San Mateo County Planning
Commission Meeting:
Ascension Heights DEIR

Baywood Park Homeowners Association

May 14, 2014

San Mateo County Planning Commission: DEIR Ascension Heights Subdivision Project

Inadequate DEIR: Air Quality

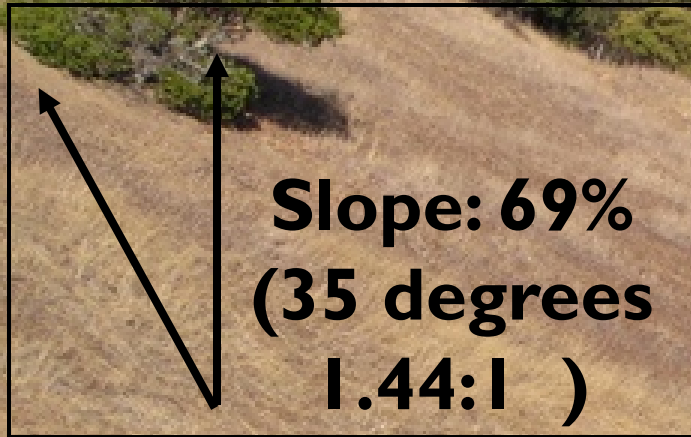
- ▶ Extremely high pollution levels calculated (DPM 250ug/m³); no plan to halt operations during dangerous atmospheric conditions
- ▶ No analysis of Acute Health Risks (stroke, heart attack, death, asthma, COPD)
- ▶ Fugitive dust [50+ mi/hr winds (monitoring not defined); Inadequate watering]
- ▶ Must include:
 - ▶ Halt grading operations during “Spare the Air” days
 - ▶ All exposed surfaces shall be watered at a frequency adequate to maintain minimum soil moisture of 12 percent. Moisture content can be verified by lab samples or moisture probe.
 - ▶ All trucks and equipment, including their tires, shall be washed off prior to leaving the site.
 - ▶ Minimizing the idling time of diesel powered construction equipment to two minutes.
 - ▶ Requiring all contractors use equipment that meets CARB’s most recent certification standard for off-road heavy duty diesel engines.

Aesthetics (cont'd)

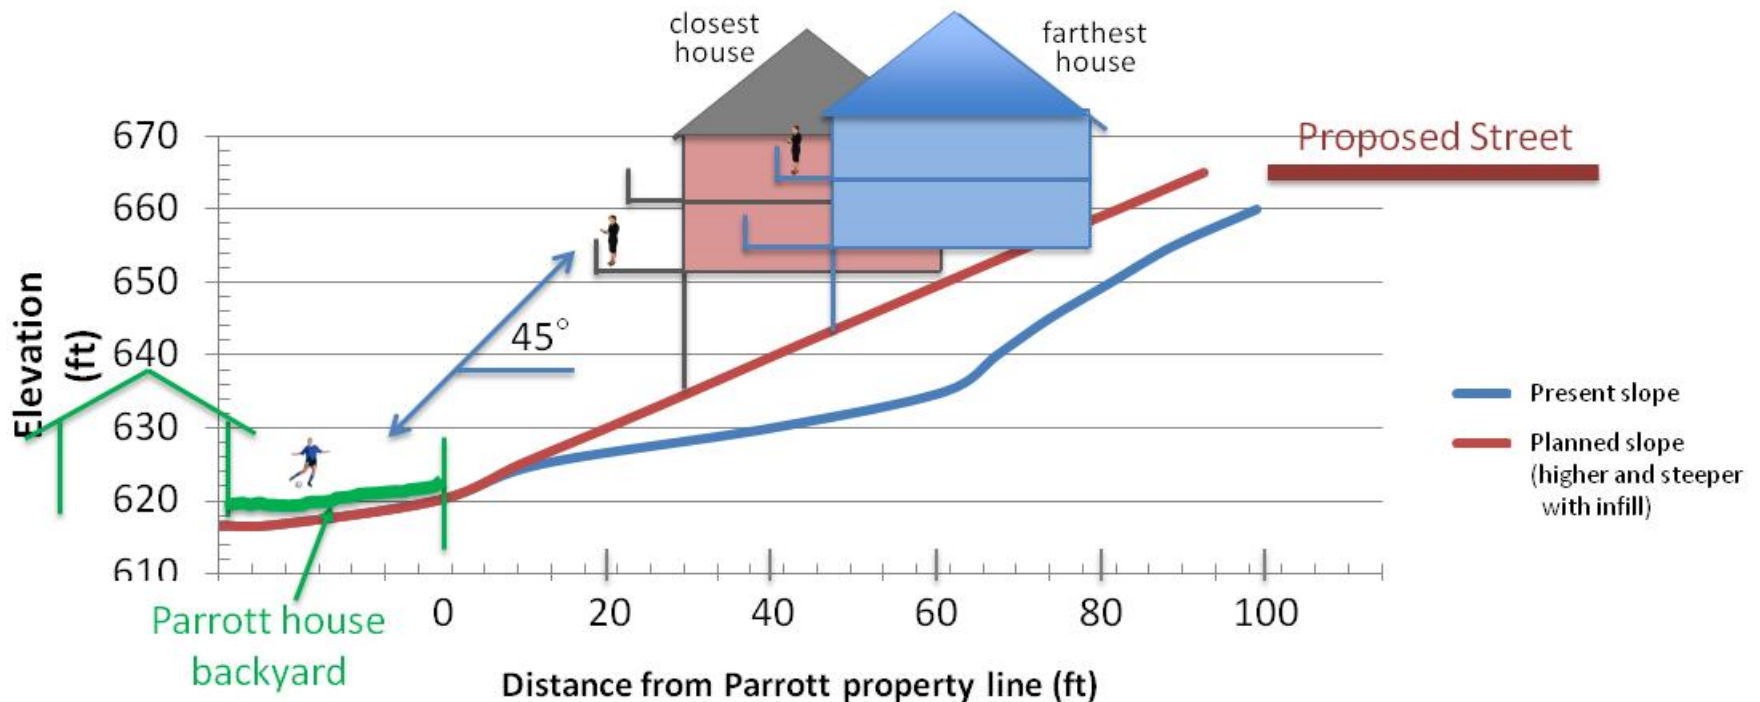
- ▶ **Lack of data for Landscape Plans**

- ▶ Impact on Parrott homes backyards from planned landscaping (e.g., due to shade, invasive growth) is not described

Aesthetics (cont'd)

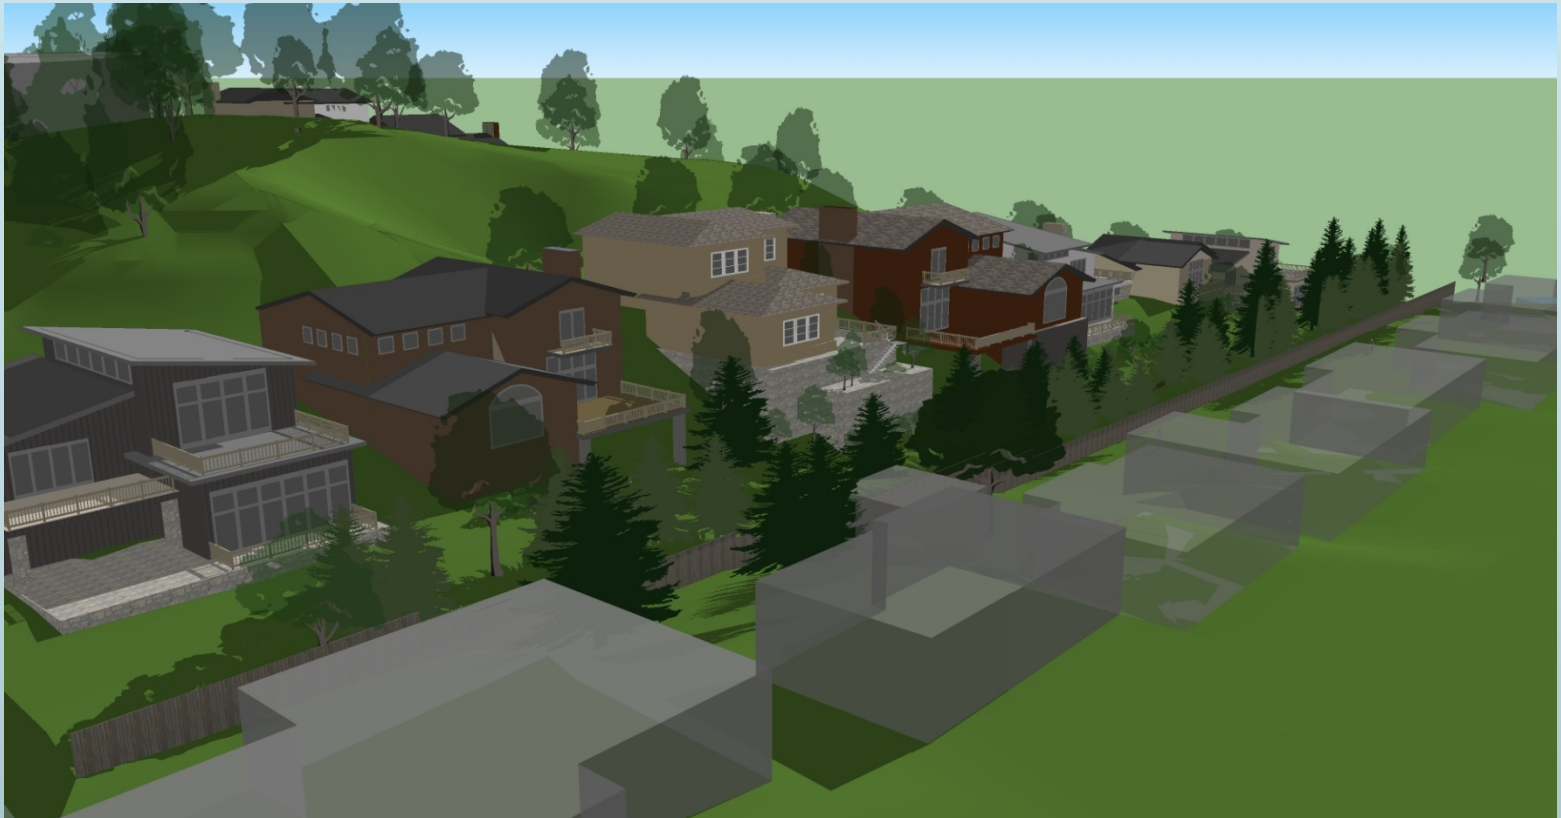
- ▶ Rendering provided by applicant during 2010; shows only one tier
- ▶ Request similar rendering, with ALL houses shown and without the mature pine trees (which do not exist and which would be planted per the DEIR as 5-gallon replacements)
